# CITY OF ALBUQUERQUE

RE: **Lot 16 Block 6 Unit 18, S.A.D. 228**  
**6512 Kimmick Dr. NW**  
**Grading and Drainage Plan**  
**Engineers Stamp Date 9-7-17 (D10D003M16)**

Based upon the information provided in your submittal received 9/13/17, this plan is cannot be approved for Grading Permit until the following comments are addressed

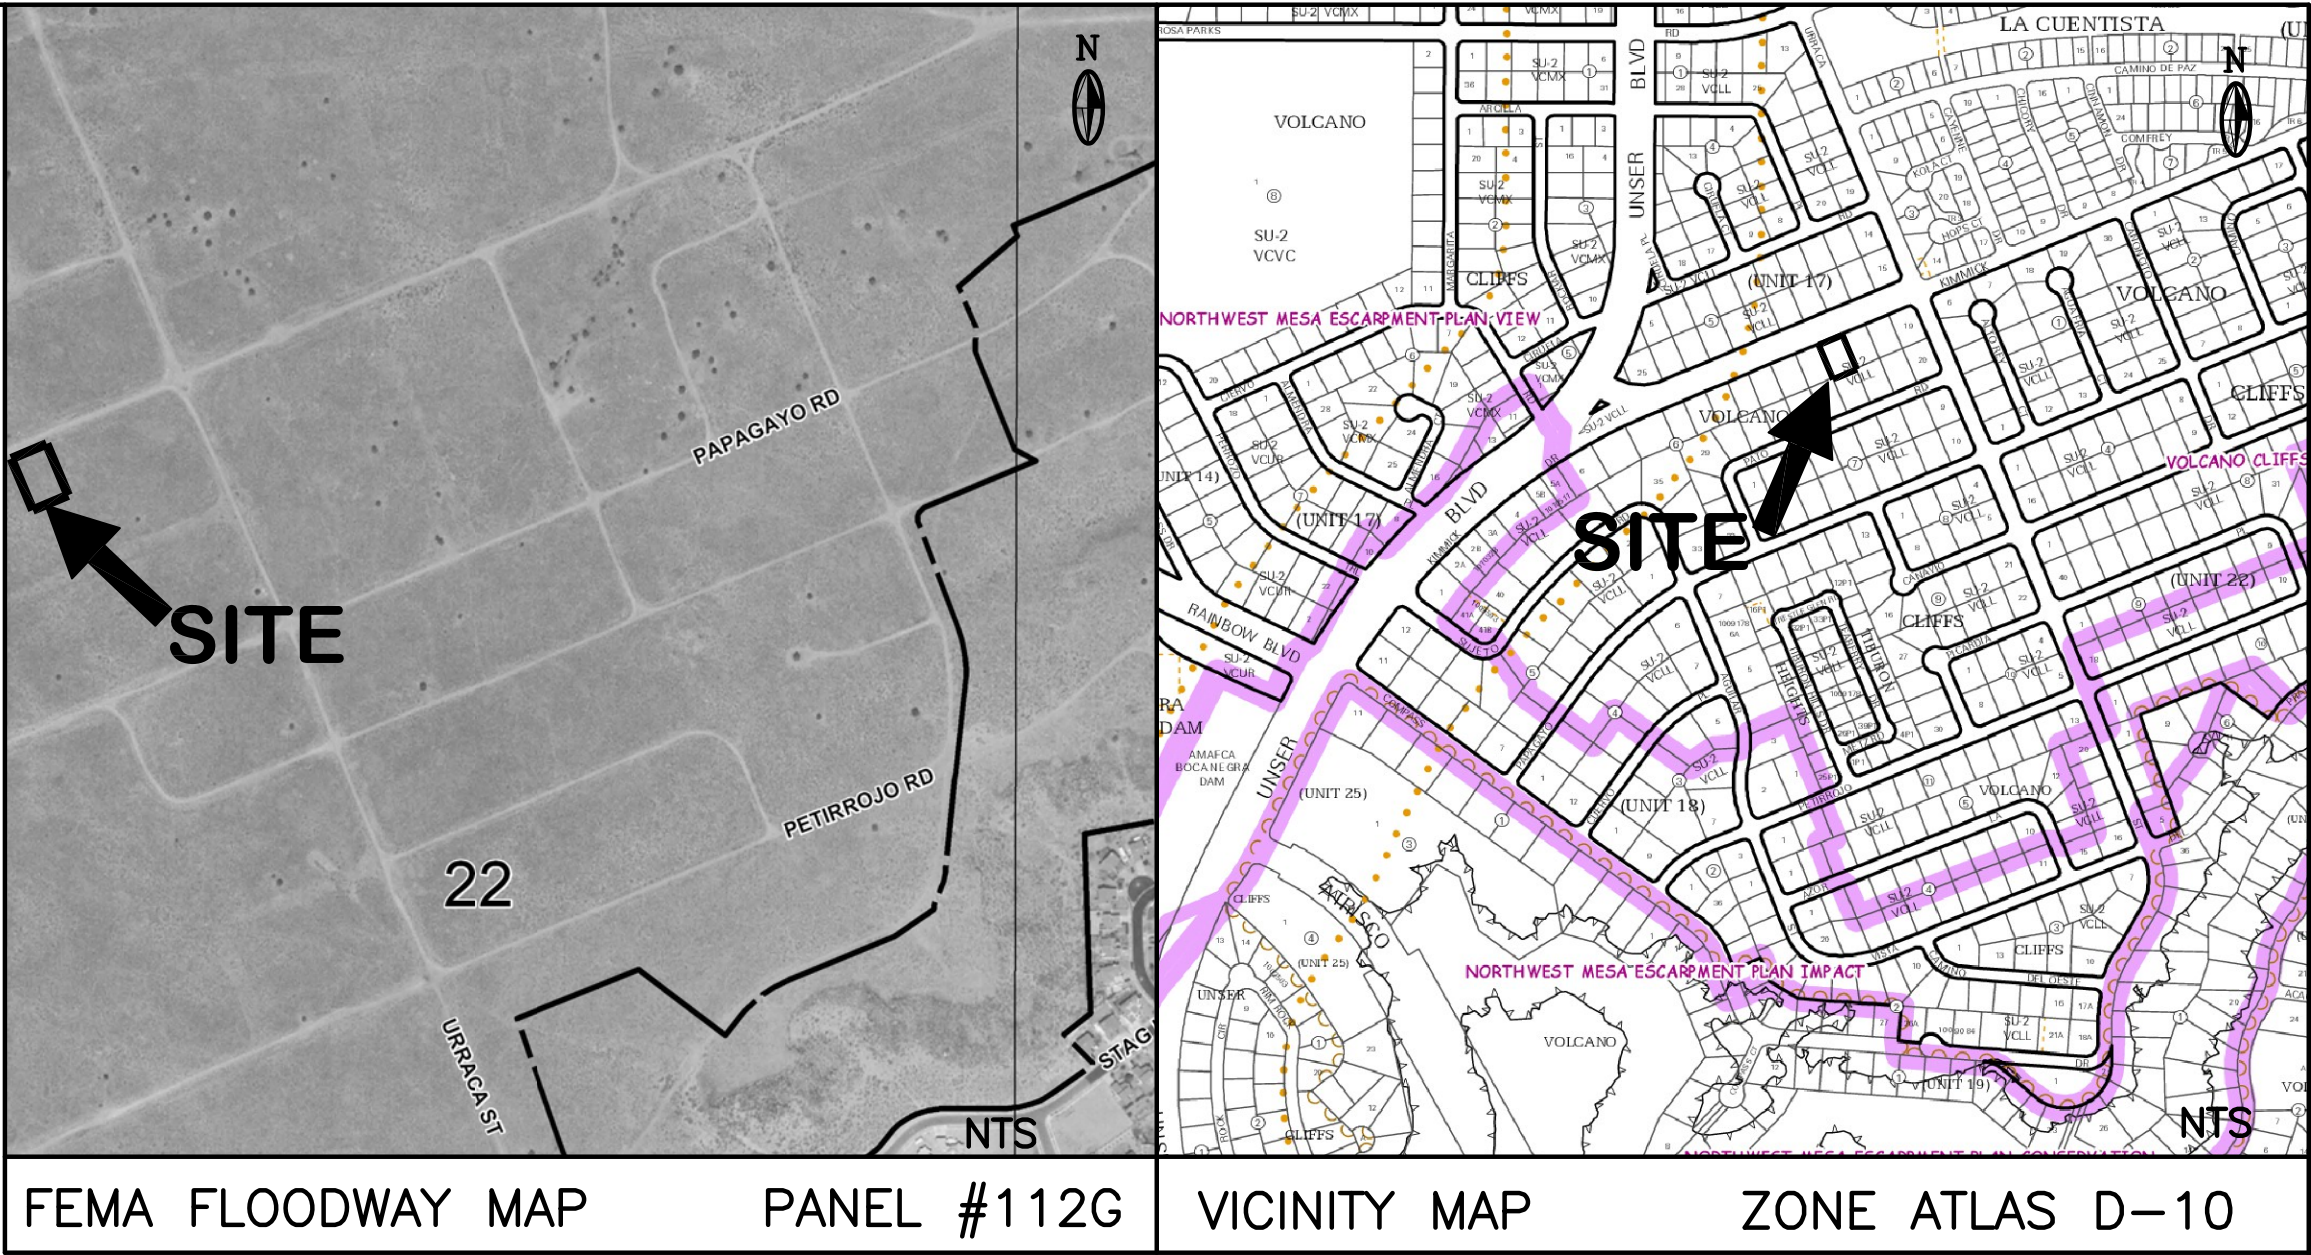
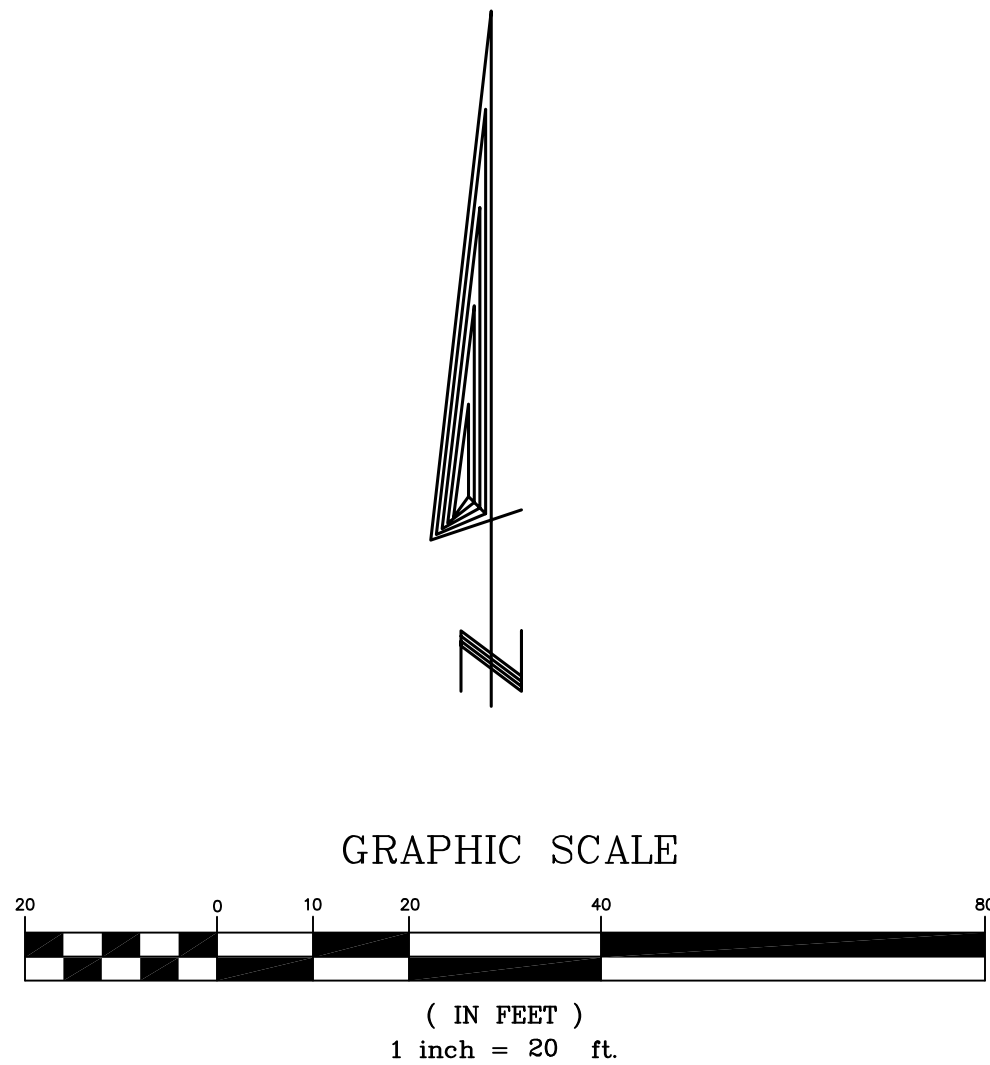
- Show the 7' PUE in the rear yard. Flows should travel from east to west in this area and out to Pato Rd.

**Prior to Building permit approval a Pad Certification will be required, provided by the Engineer signed and dated or a registered Land Surveyor with as-build spots.**
